September 30, 2014

RE: Station Park Green

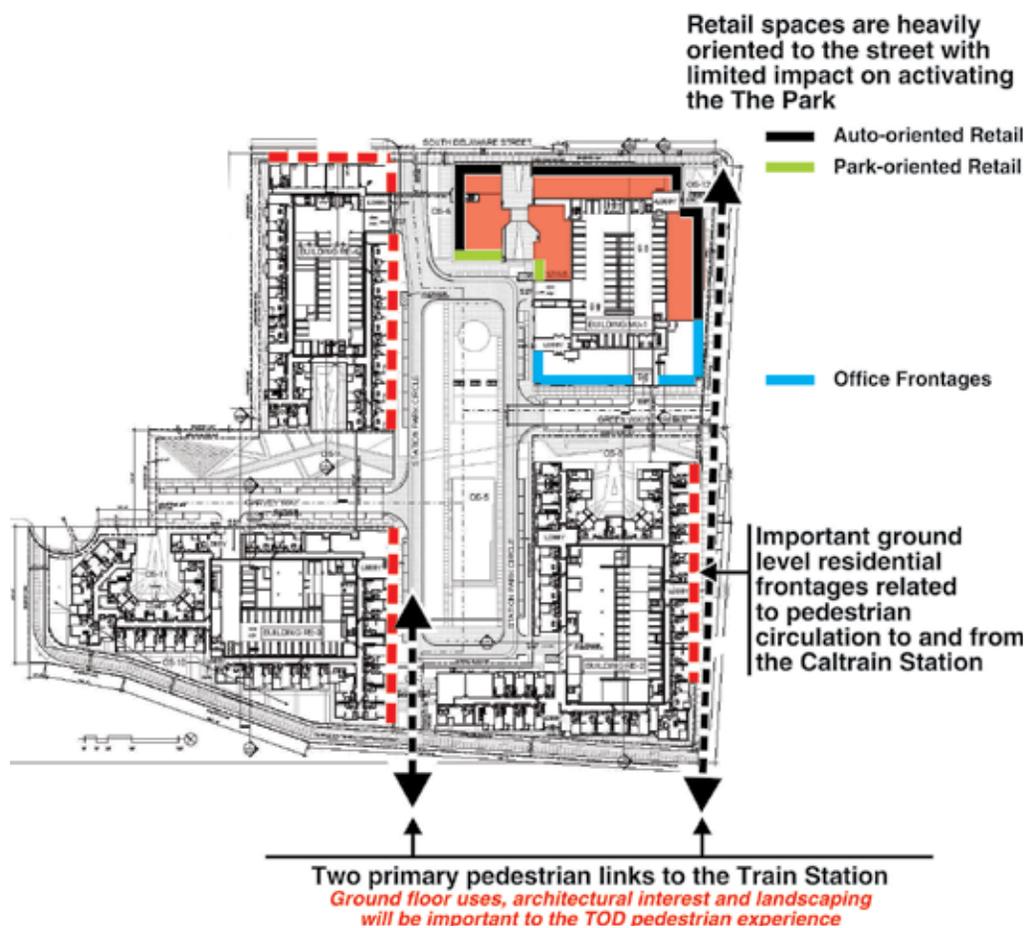
However, the proposed design appears in many regards quite different from that illustrated in the Specific Plan Design Guidelines adopted by the Commission. The illustrations contained in the Specific Plan Design Guidelines include many of the characteristics noted below on one example photo from the design guidelines.

In conducting their review, the Planning Commission may wish to examine the following issues:

- The heavy surrounding frame for several of the buildings.
- The amount of visual interest within the bounding frame of the boxes.
- The extent of visual variety and architectural detail provided.
- The project's strong urban architectural form and character.
